**OFFICIAL AGENDA  
LANDSCAPE ADVISORY BOARD  
CITY OF STARKVILLE, MISSISSIPPI  
MEETING OF WEDNESDAY, SEPTEMBER 2, 2020  
2<sup>ND</sup> FLOOR OF CITY HALL IN ROOM 211  
110 WEST MAIN STREET AT 11:00 AM**

**To:** Members of the Landscape Advisory Board  
**From:** Daniel Havelin, City Planner (662-323-2525 ext. 3136)  
Emily Corban, Assistant City Planner (662-323-2525 ext. 3138)  
**Subject:** LW 20-01 Request for Landscape Waivers from tree protection and perimeter parking lot landscape requirements at 600 Highway 12 West in a C zoning district with the parcel number 102F-00-053.00  
**Date:** September 2, 2020

The purpose of this report is to provide information regarding a Landscape Waiver Request by Zach Foster, of Neel-Schaffer, Inc. on behalf of Castle Properties for 3 landscape waivers for a proposed shopping center development located at 600 Highway 12 West in a C zoning district with the parcel number 102F-00-053.00. Please see attachments 1- 4.

**LANDSCAPE WAIVER EXHIBIT**

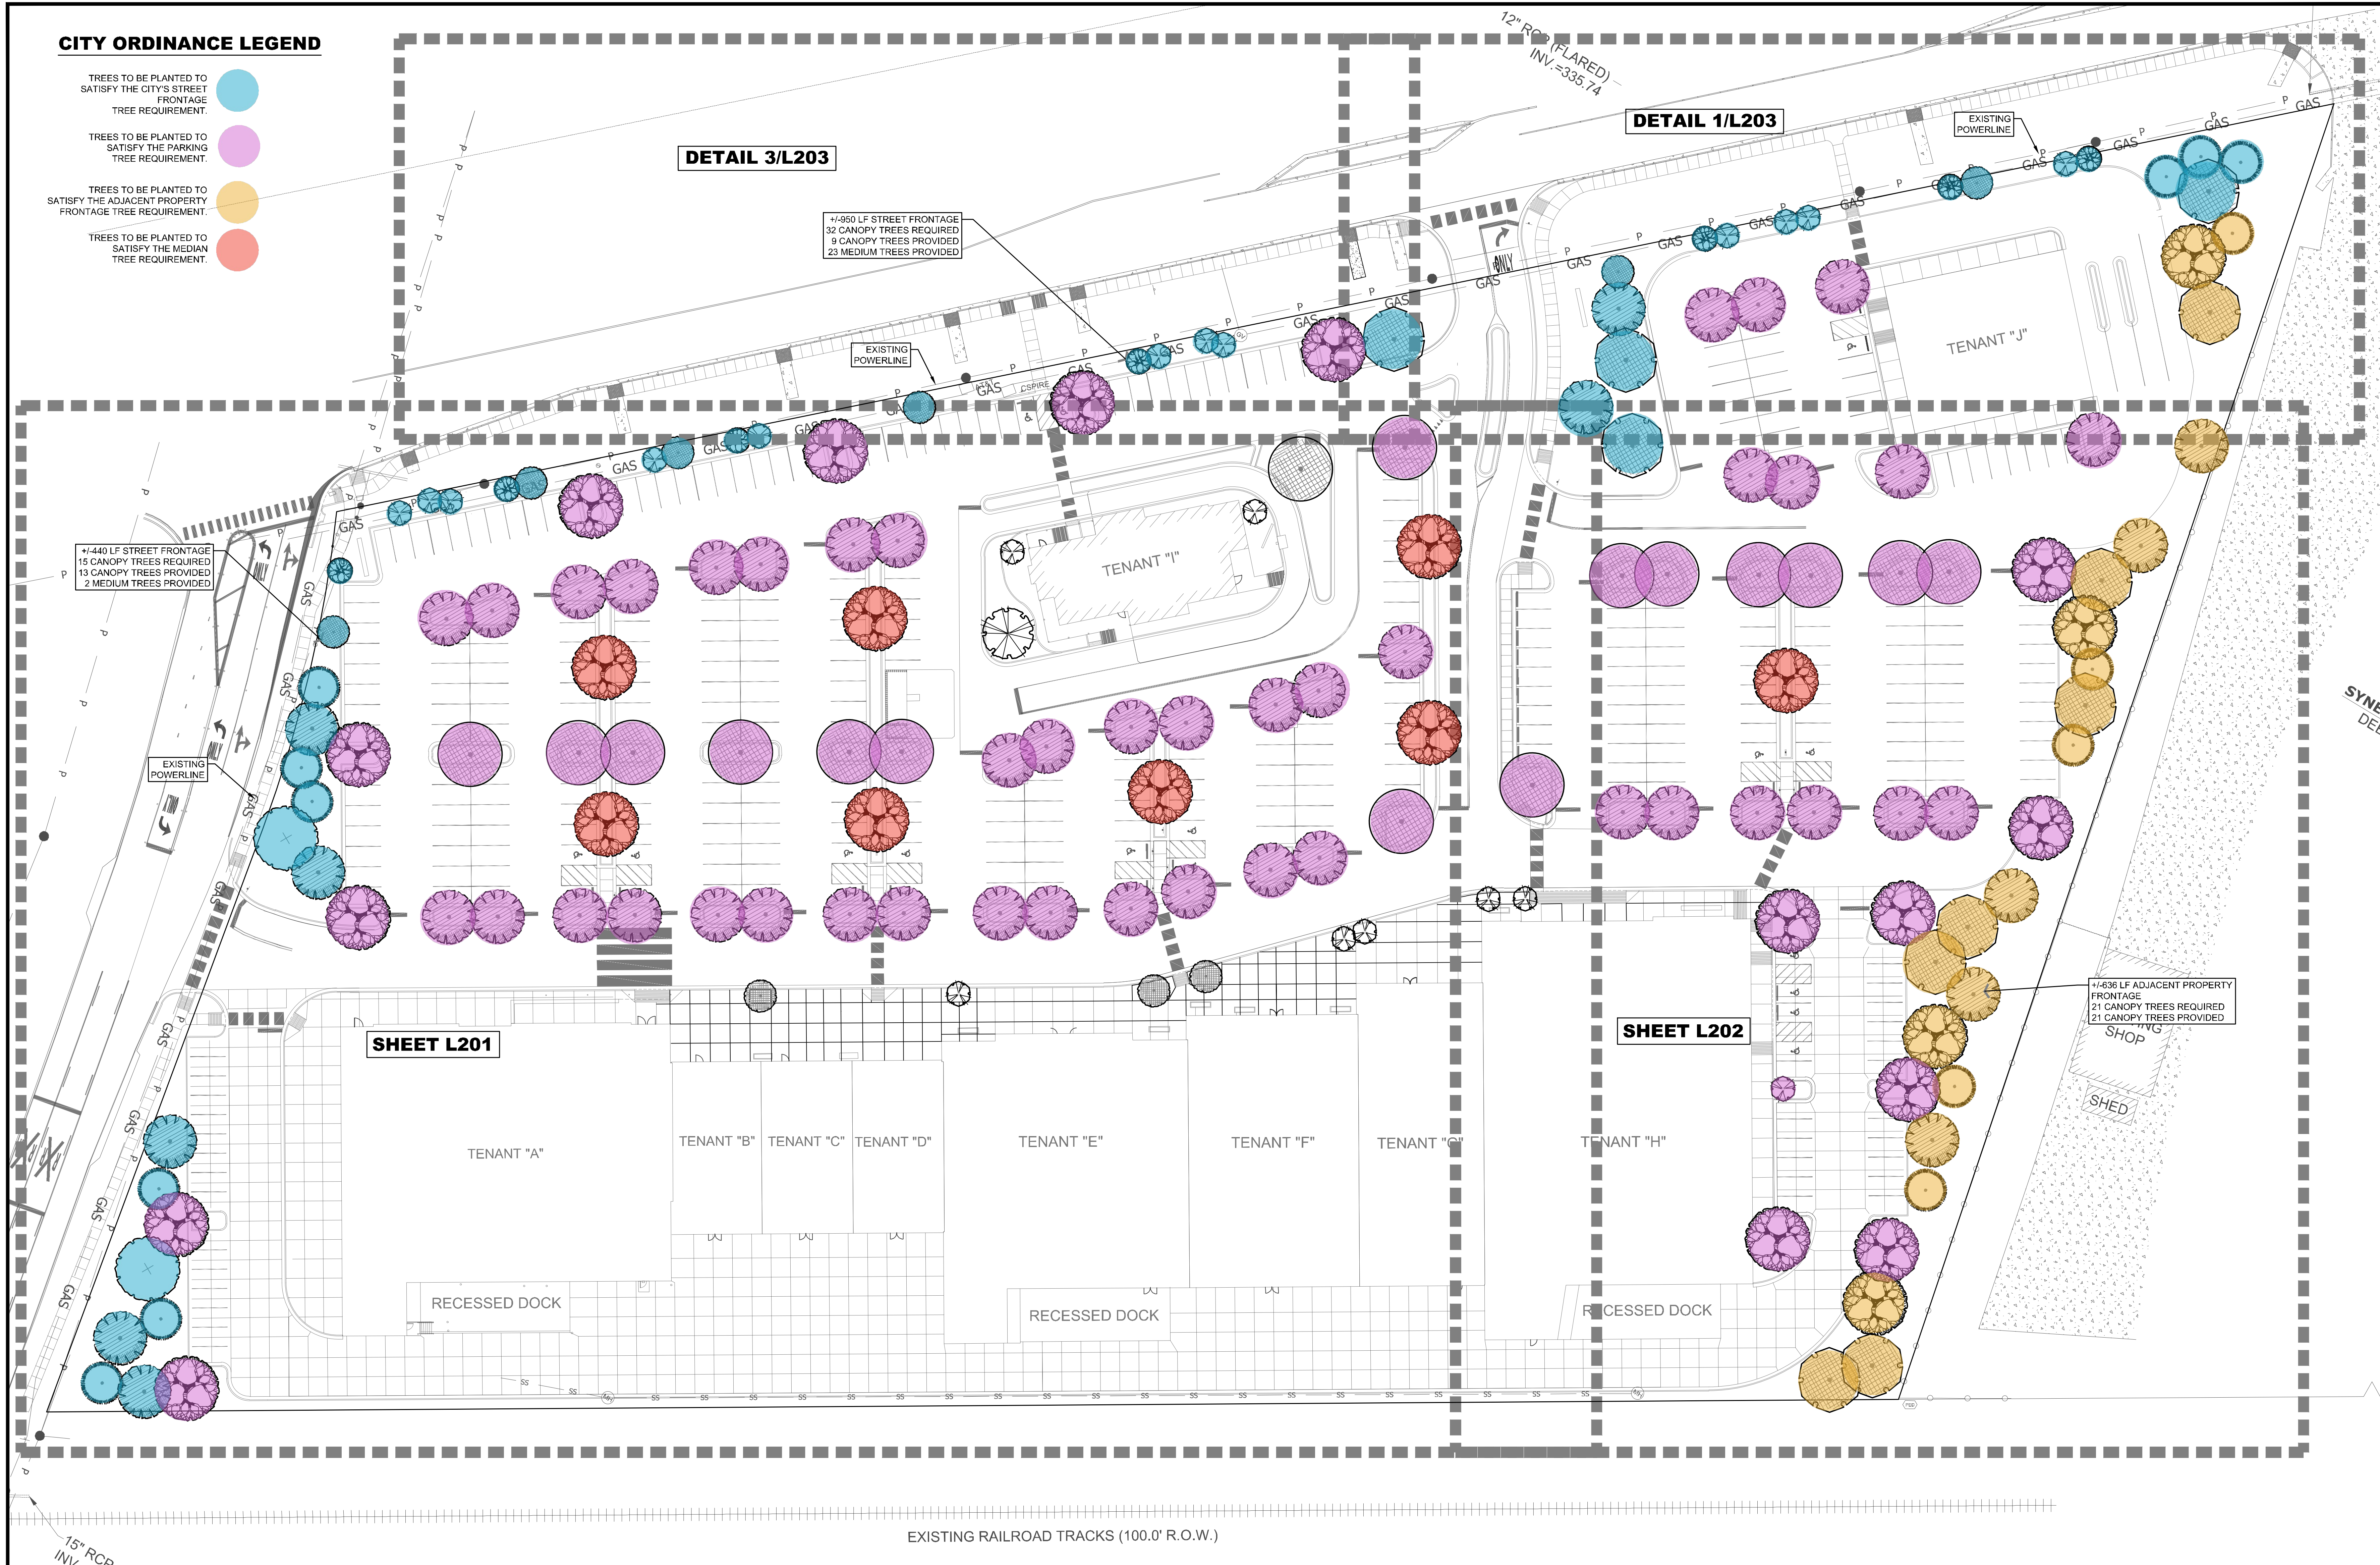
- a. **Request:** request waiver to remove all 63 existing trees within the building setback lines
  - b. **Reasoning:** to accommodate the footprint of the proposed development and required number of parking stalls in lieu of the requirements.

- a. **Request:** request waiver to install an attractive wooden privacy fence along the top of the proposed retaining wall at the rear lot line in lieu of the 26 canopy trees required by Section 14.6.2 – Development Standards Chart

WAIVER REQUESTED TO REMOVE TREES

WAIVER REQUESTED TO REMOVE TREES

WAIVER REQUESTED TO INSTALL PRIVACY FENCE ALONG EXISTING RAILROAD TRACKS (100.0' R.O.W.) TOP OF RETAINING WALL IN LIEU OF CANOPY TREES ALONG REAR LOT LINE

WAIVER REQUESTED TO REMOVE TREES

In the opinion of the Planning Department the proposed variance request could meet the criteria for variance review and approval. The request to remove approximate +/-63 trees from within the building setback lines could be justified by the applicant's proposal to install canopy trees around the perimeter as required. The current plan shows approximately +/-64 canopy trees around the perimeter. The conceptual plan shows approximately 11 small trees along the perimeter. Those trees will be required to be canopy trees. Thus, bringing the total number of proposed canopy trees on the perimeter of the property to +/-75. The request to remove the required canopy and shrubs on the southern property line could be justified because of the amount of utilities being proposed in the rear of the building. In addition to underground water and sewer, overhead power will most likely be placed in the rear of the building creating conflict for any proposed trees. If approved, staff recommends requiring an 8' good neighbor fence along the length of the southern property line.
